INGHAM WETLAND COMPLEX
SHORELINE ARMORING
EMMET COUNTY, IOWA
PROJECT NUMBER: 19-01-32-02

April 22, 2022

This Addendum is issued to modify, explain or correct the original Drawings and Specifications, and is hereby made a part of the Contract Documents. Please attach this Addendum to the Project Manual in your possession. Insert the number and issue date of this Addendum in the blank space provided on the Proposal Form.

SHEET B.01

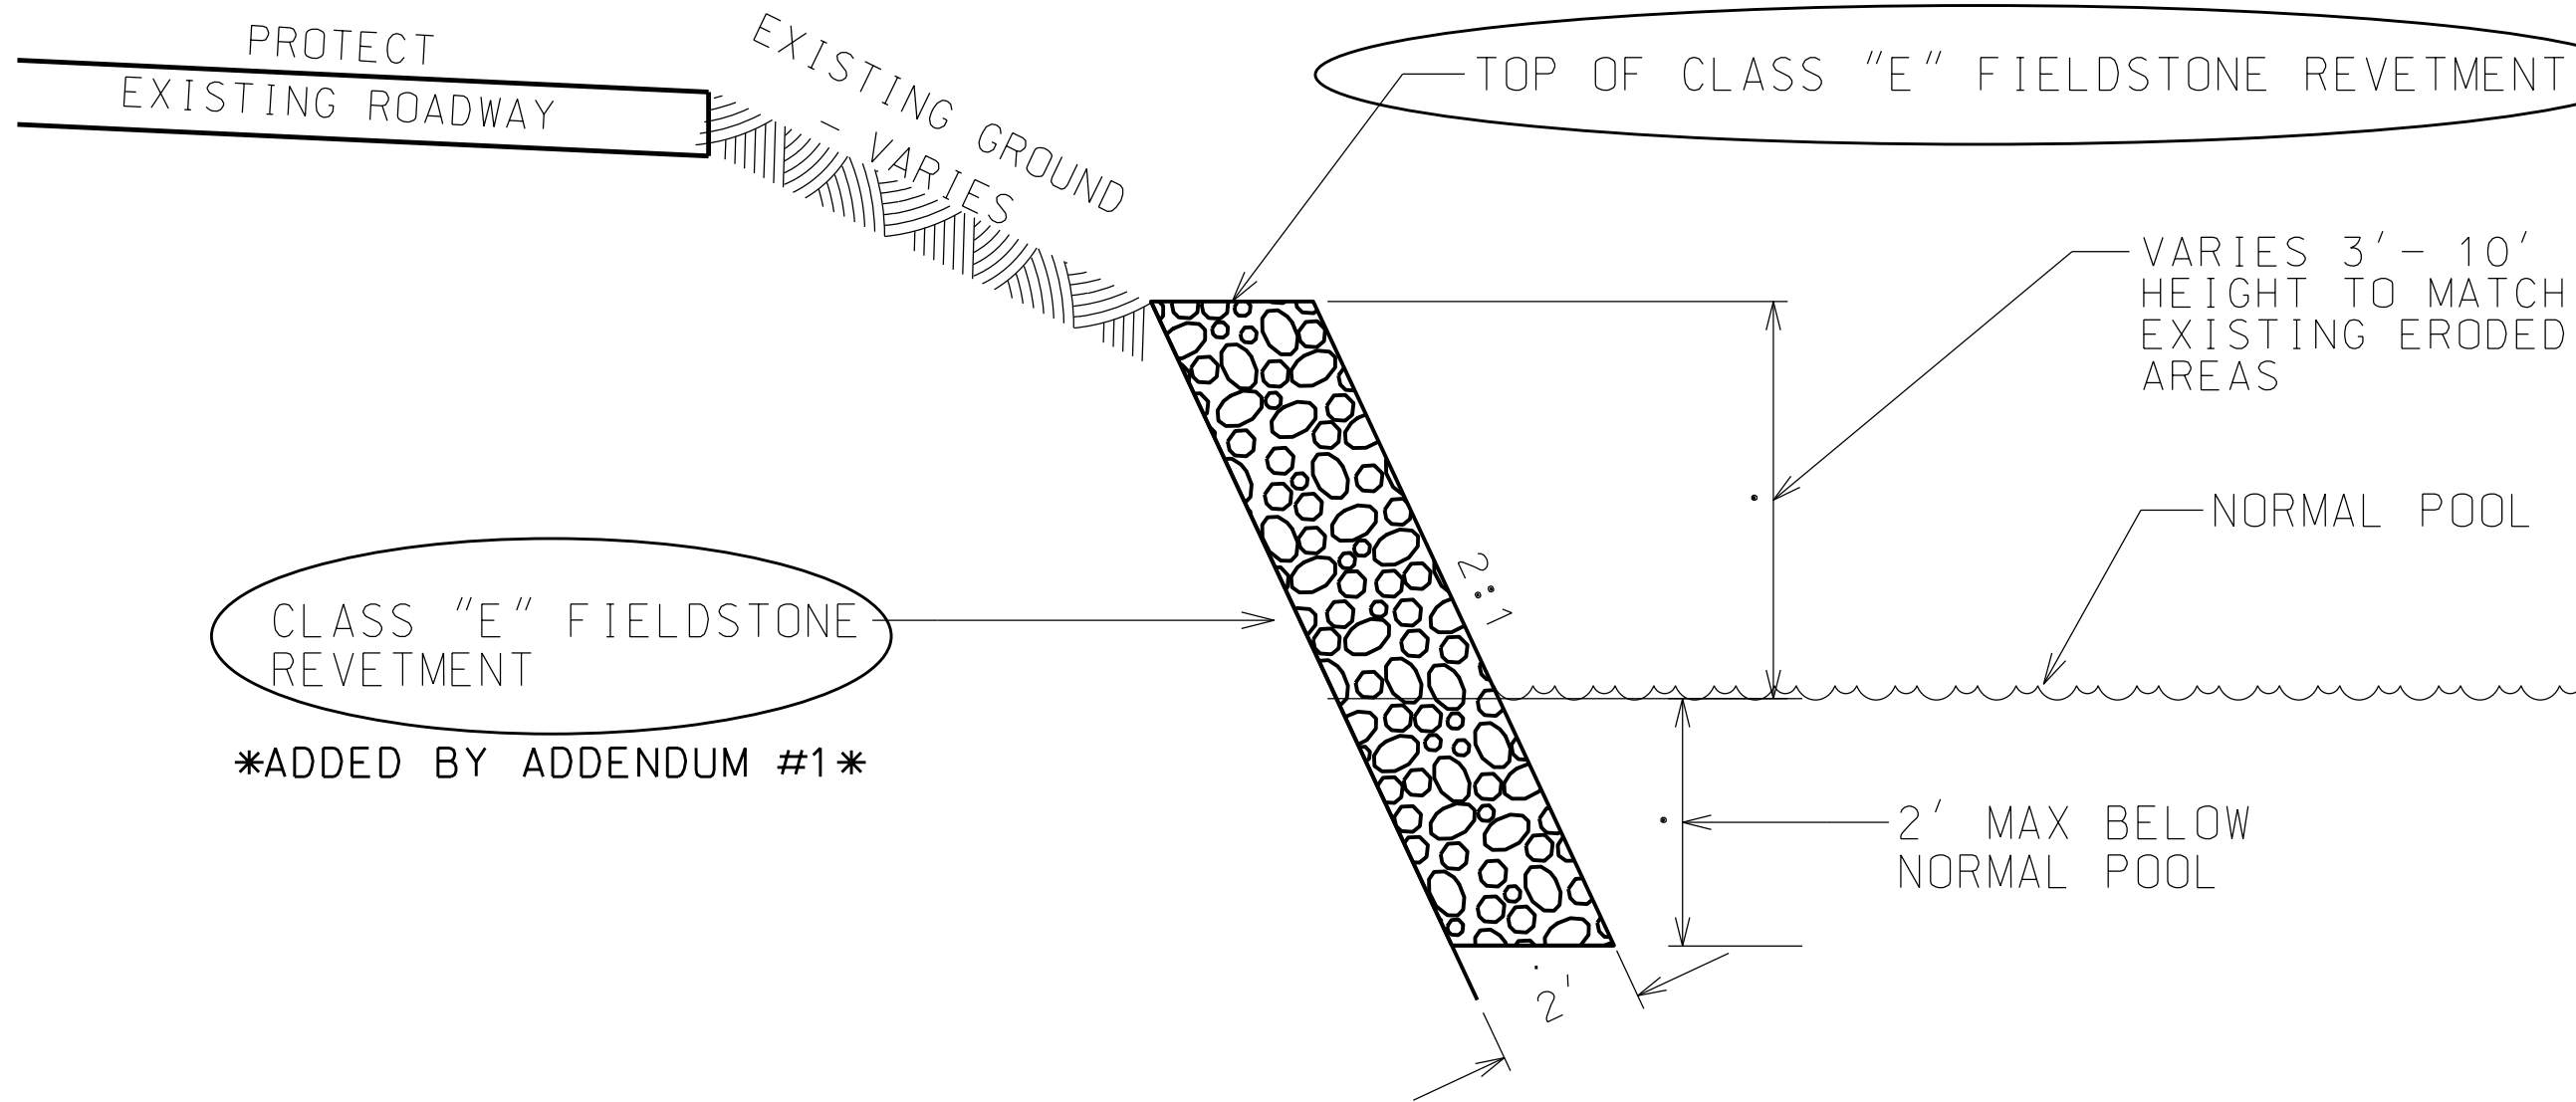
- A. "TOP OF FIELDSTONE" has been changed to "TOP OF CLASS "E" FIELDSTONE REVETMENT". Upper right portion of sheet.
- B. "CLASS "E" FIELDSTONE REVETMENT" has been added. Middle left portion of sheet.
- C. "1850" has been changed to "2500". Lower right portion of sheet.
